**FILE** P. I. No. 720125-, Fulton-Cobb Counties **OFFICE** Preconstruction  
BHF-STP-001-5(24)  
Northside Parkway at Chattahoochee River including  
US 41 Widening **DATE** December 7, 2006

**SUBJECT: PROJECT CONCEPT REPORT**

**SUBJECT: CONCEPT REPORT**

**PROJECT CONCEPT REPORT**

## SR 3/US 41/NORTHSIDE PKWY/COBB PKWY

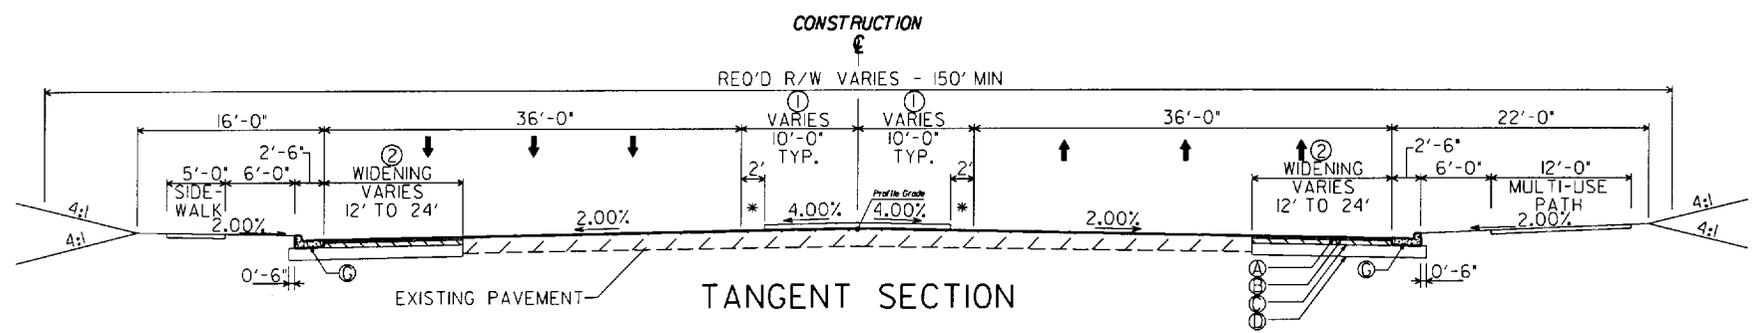
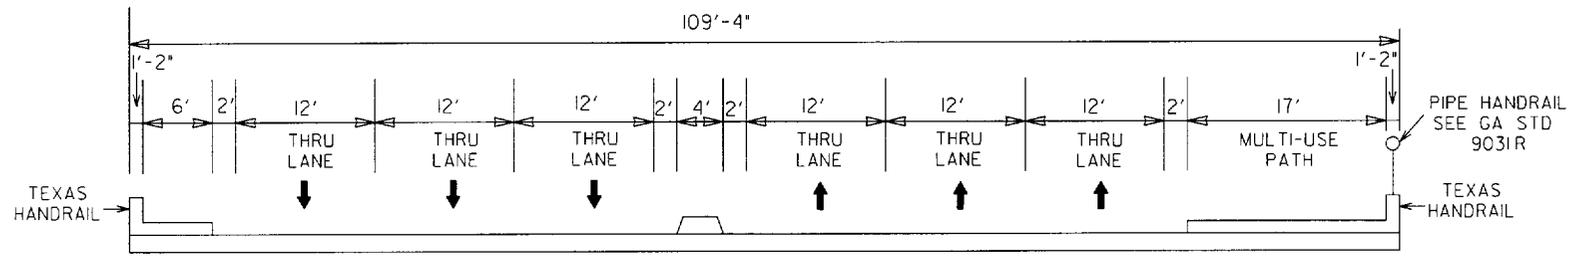
- MA to provide information in the concept report regarding the inclusion of the bike path for the project.
- MA to update bridge typical section for concept report to depict level of protection for pedestrians.
- MA to verify signalization locations provided in the concept report.
- MA to provide additional right-of-way on concept drawing for sediment basins.
- MA to provide updated right-of-way cost estimate due to additional right-of-way requirement for sediment basins.
